F6 EXTENSION STAGE 1 EIS

TRAFFIC AND TRANSPORT REVIEW

FOR
DEPARTMENT OF PLANNING AND ENVIRONMENT

Project No: P3582

Figure 3.1: Absence of Pedestrian and Cyclist Facility Markings

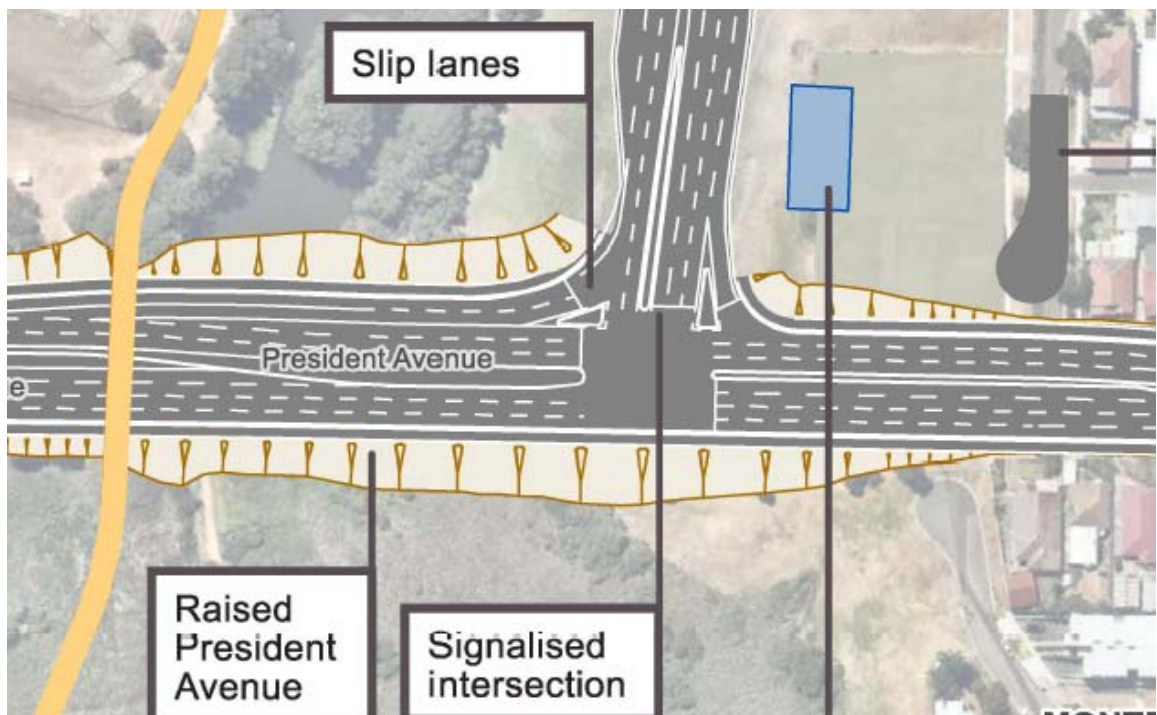
The intersection layout plan presented in Figure 6-10 in the EIS (see Figure 3.1) does not show pedestrian and cyclist facilities through the intersection nor is there any commentary as to how pedestrians and cyclists would be provided for through at-grade crossing locations and line marking. This is inconsistent with the detail of the line marking shown in Figure 6-11 at the Princes Highway / President Avenue intersection layout plan.

Figure 3.2: Potential for Lane Blocking and Lane Under-Utilisation

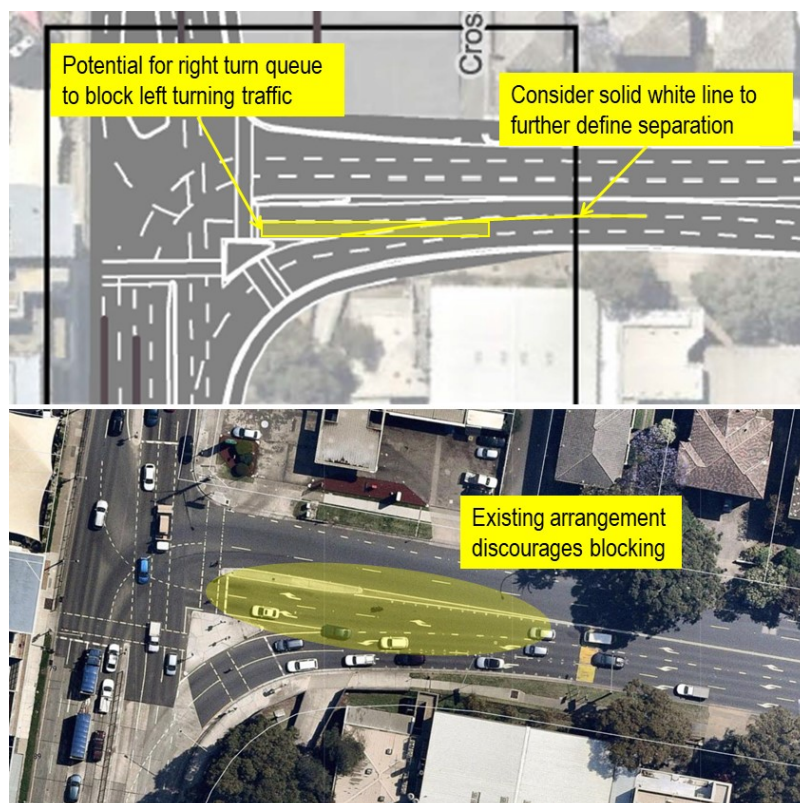
The proposed arrangements as shown in Figure 3.2 for the right turn out of President Avenue introduce the potential for queuing back from the right turn pocket into the left turn lane, introducing capacity and safety issues. Whilst it is acknowledged that the figure provided in the EIS is a concept only, the suggested modification below is considered to be valuable to clarify lane queuing arrangements for safety.

3. Consider as part of the detailed design, the line marking detail at the President Avenue approach to the Princes Highway signalised intersection to minimise the risk of right turning vehicles queuing back through the marked left turn lanes.

Figure 9.1: TAFE and Lachal Avenue Access Changes

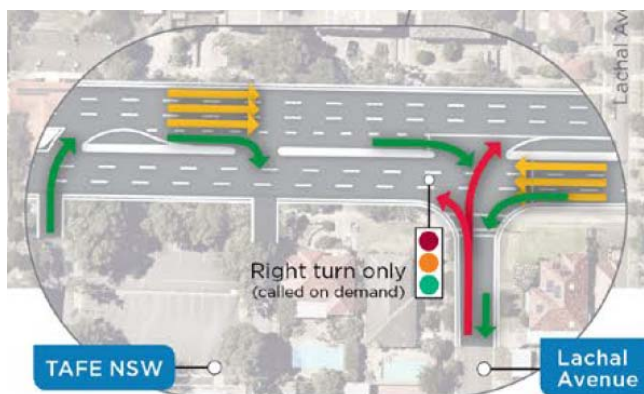
The revised access arrangements in the PIR for this area shown in Figure 9.1 are supported as they provide a much safer arrangement for entries and exits. Traffic entering Lachal Avenue is 'protected' by means of a signal which stops opposing westbound traffic in President Avenue and Lachal Avenue is provided as one way southbound. This new signal will also provide gaps for right turning traffic exiting the TAFE site to move across the westbound carriageway and into the storage area in the middle of President Avenue to accept a gap in eastbound flows. Similarly, the new signal at Lachal Avenue will provide gaps for traffic from President Avenue to turn right into the site.

This is a substantial improvement from the EIS configuration however the only potential issue is the profile of the driveway crossover into the TAFE site. What could occur, due to the limited separation between the signal stop line in President Avenue and the right turn in storage pocket, is that a vehicle may commence its right turn just as the President Avenue signal goes green. Given this distance is about 45m producing a gap of about 8 seconds, there is a possibility that an entering vehicle will prop at the crossover and have its rear protruding into the kerbside lane as a westbound vehicle approaches. There is however adequate sight distance for a westbound vehicle to observe this occurring and take appropriate action if required.

Figure 9.2: Traynor Avenue / Cross Street / President Avenue Changes

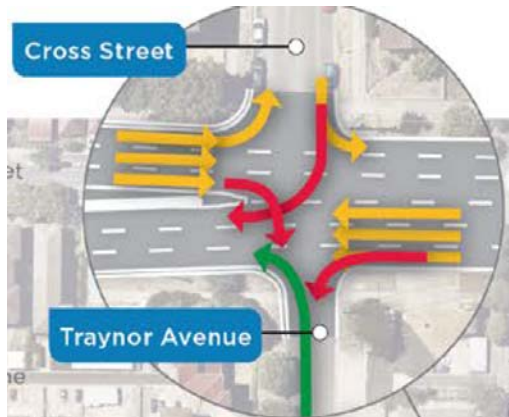
Traynor Avenue is converted to one-way northbound with only left turns out allowed at President Avenue, as shown in Figure 9.2. This is a much-improved concept compared to the EIS concept and compliments the one-way southbound change at Lachal Avenue.

The restriction of Cross Street to left in / out is also supported due to its safety benefits and with right turns out being able to be made via the West Botany Street intersection instead.

Figure 9.4: Moorefield Avenue / West Botany Street Configuration

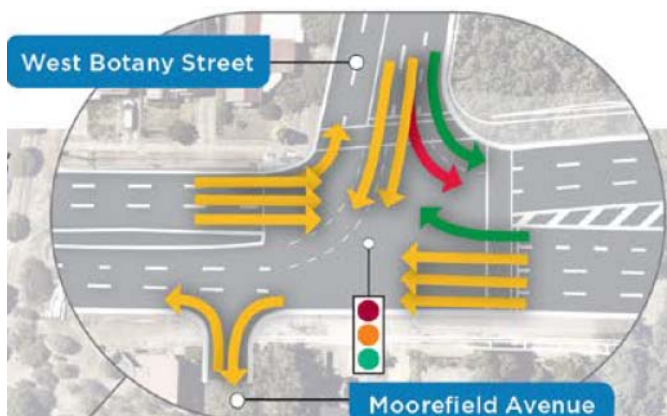
Retaining Moorefield Avenue as left in/out with no cul-de-sac as shown in Figure 9.4 is supported as it provides for improved circulation, better dispersion of traffic and better access to the parking for the small commercial centre adjacent to this street. At West Botany Street, the additional (separated) left turn lane will benefit the capacity and safety of the intersection and is also supported.

Figure 9.5: Civic Avenue / President Avenue Configuration

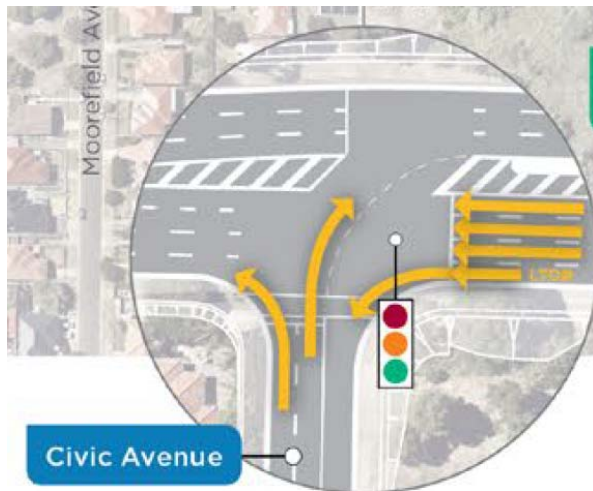
The modification to include signalisation of this intersection is supported as Civic Avenue is the only controlled right turn out opportunity into President Avenue from Moorefield Estate.

The signalisation of this intersection also assists with the ability for left turning vehicles from Civic Avenue to join the right turn queue for turns into West Botany Street further east, although keeping clear through this intersection in the westbound direction could be influenced by the extension of the central painted median.
